KIRKBY – BESS SITE DRAINAGE ADDENDUM

Coopers Lane, Kirkby

KIRK-BML-XX-XX-RP-C-0513

29th September 2025

Impermeable Liner Section
Alternative concrete pad option

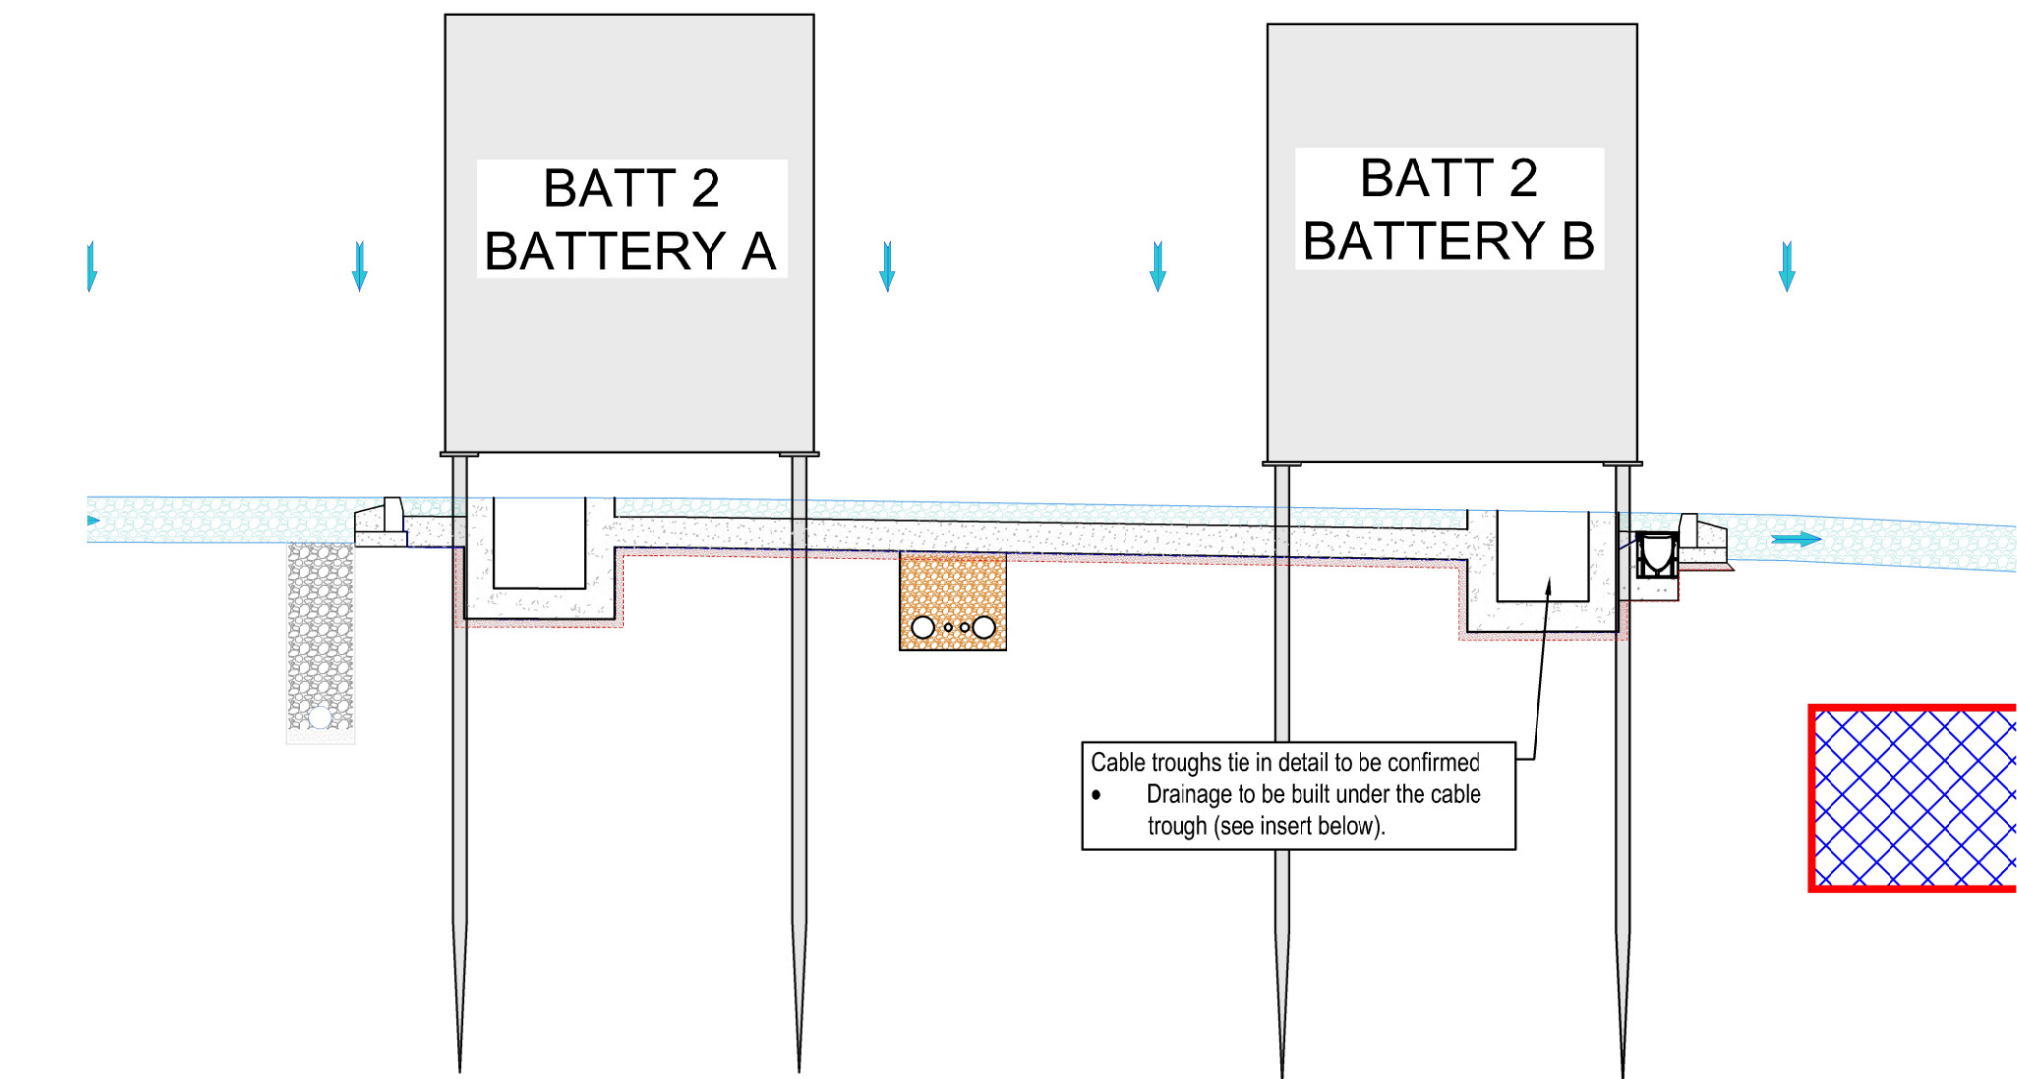
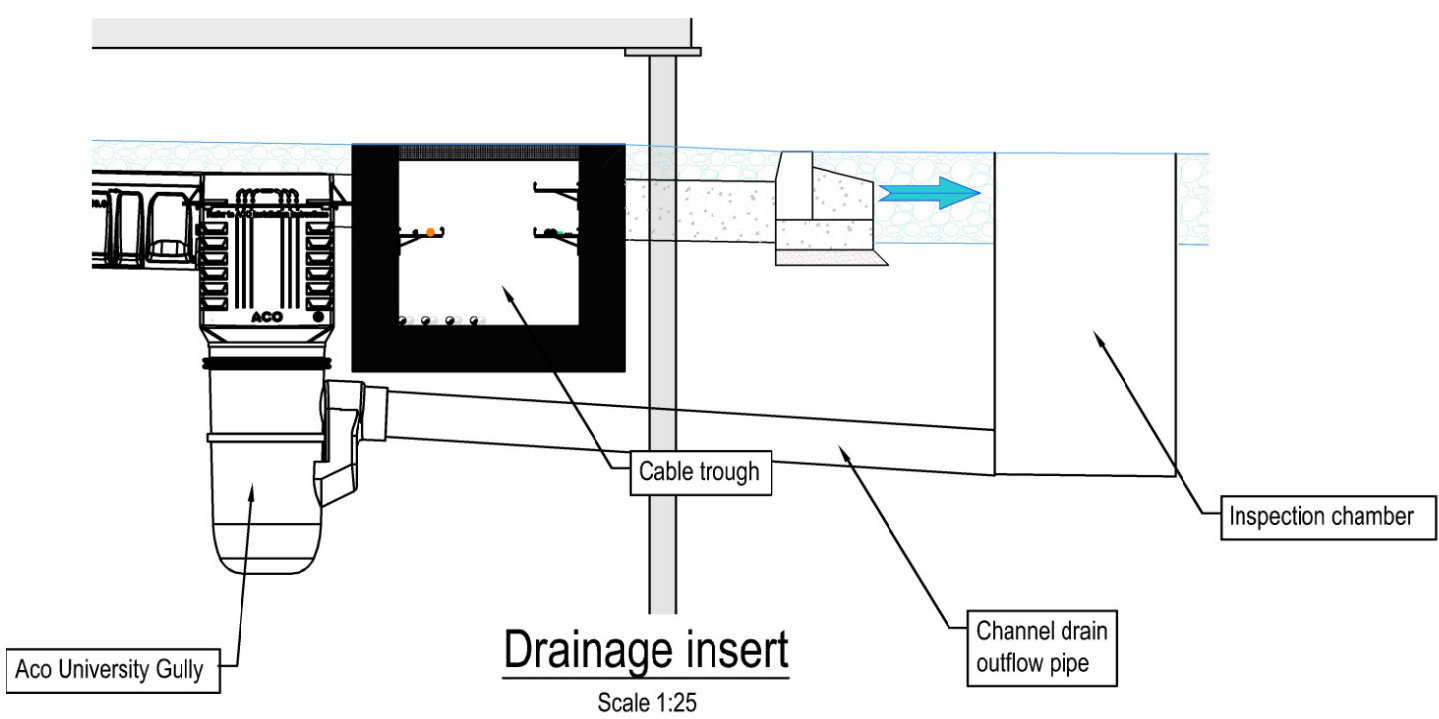
The original proposal included the use of an impermeable membrane beneath the entire site to prevent surface water infiltration under normal rainfall conditions. However, due to the poor ground conditions at the site the use of screw piles as method for the battery unit foundations is required, this would result in several hundred penetrations of the membrane. As a result, this solution is deemed impractical at this site. The proposal is to now contain any fire water runoff from the batteries directly in the position of the battery units using concrete apron bunds.

The area underneath the battery units will be paved with an impermeable reinforced concrete pad of dimension 13.2m x 8.9m surrounded by HB2 kerbs with 125mm upstand (see **Appendix B**). In addition, the concrete slabs will be underlain with a sheet of damp proof membrane (DPM) to prevent any possible infiltration of fire water into the ground underneath in the event of cracking.
